SUBDIVISION REPORT - CONCEPT/DEVELOPMENT PLAN

► **FILE #:** 9-SF-26-C **AGENDA ITEM #:** 30
9-E-26-DP **AGENDA DATE:** 9/10/2026

► **SUBDIVISION:** PRICES POINT CHURCH EXPANSION

CONCEPT PLAN / DEVELOPMENT PLAN

CONCEPT PLAN
ROAD PLAN & PROFILE

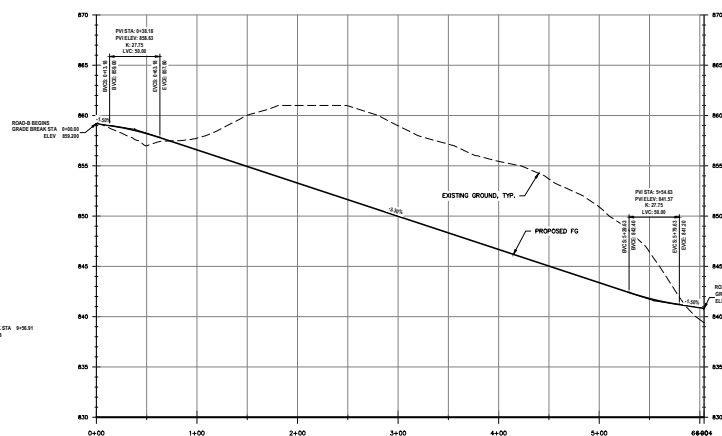
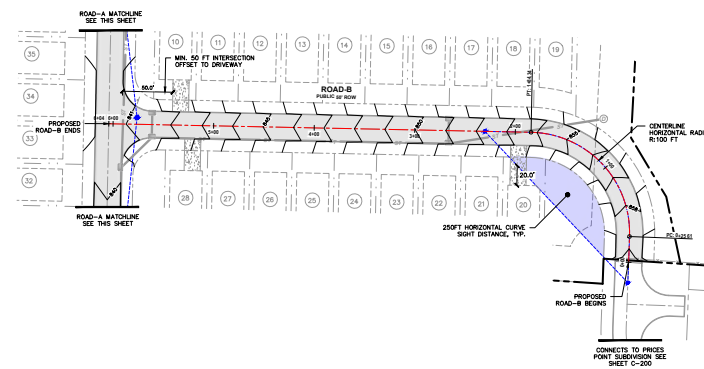
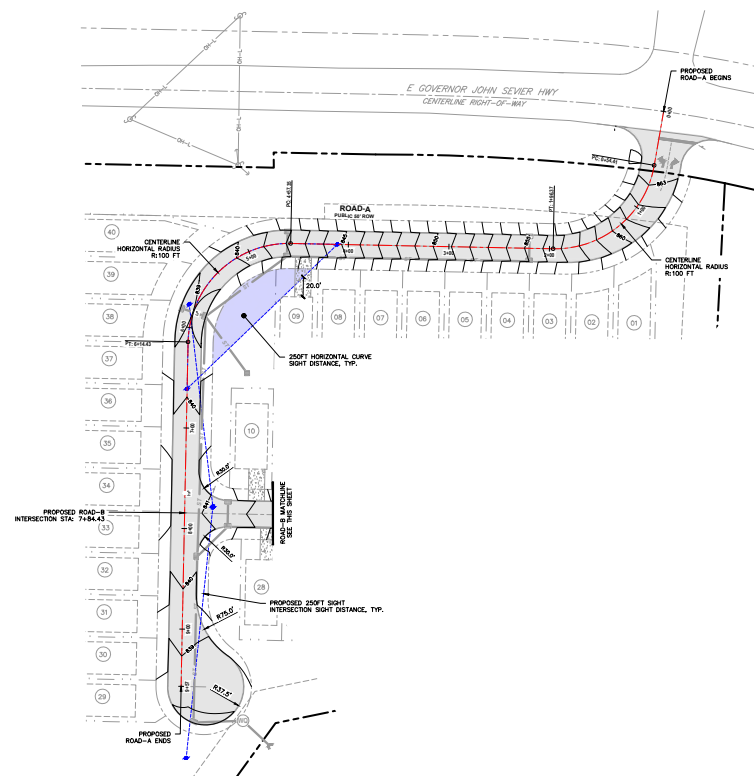
Reduce required pavement radius for Road A cul-de-sac from 40' to 37.5'.

The subject property contains physical site constraints that make the standard 40-foot cul-de-sac radius impractical. Reducing the pavement radius to 37.5 feet allows the roadway to better fit the site's existing topography while minimizing grading and site disturbance.

Given the 50% open space restriction, an alternative AASHTO-compliant turnaround configuration is proposed to reduce cul-de-sac footprint, minimizing grading and site disturbance.

A turning template for a BUS-40 design vehicle has been provided for the proposed reduced radii cul-de-sac configuration showing that no public safety hazard will be created by the reduced radius.

Reduce required ROW radius for Road A cul-de-sac from 50' to 47.5'.

The subject property contains physical site constraints that make the standard 50-foot ROW cul-de-sac radius impractical. Reducing the ROW radius to 47.5 feet will reduce grading and minimize site disturbance.

Given the 50% open space restriction, an alternative AASHTO-compliant turnaround configuration is proposed to reduce cul-de-sac footprint, minimizing grading and site disturbance.

The proposed reduction ROW radius for Road-A cul-de-sac is consistent with the proposed pavement radius reduction, leaving the same width between the edge of pavement and the ROW line as if it were a standard cul-de-sac, therefore no public safety hazard or detrimental situation will be created by the reduced ROW radius.

Reduce required horizontal radii on Road A and Road B from 250' to 100'. Reduced radii will serve as a traffic calming measure reducing traveling speeds in proposed neighborhood.

Increase maximum allowable intersection grade at intersection of Road A and W Governor John Sevier Hwy from 1% to 2%. Increased slope will improve drainage at intersection.

Increase maximum allowable intersection grade at intersection of Road A and Road B from 1% to 1.5%. Increased slope will improve drainage at intersection.

Approve based on applicants justification.

Approve based on applicants justification.

APPROVED

APPROVED

APPROVED
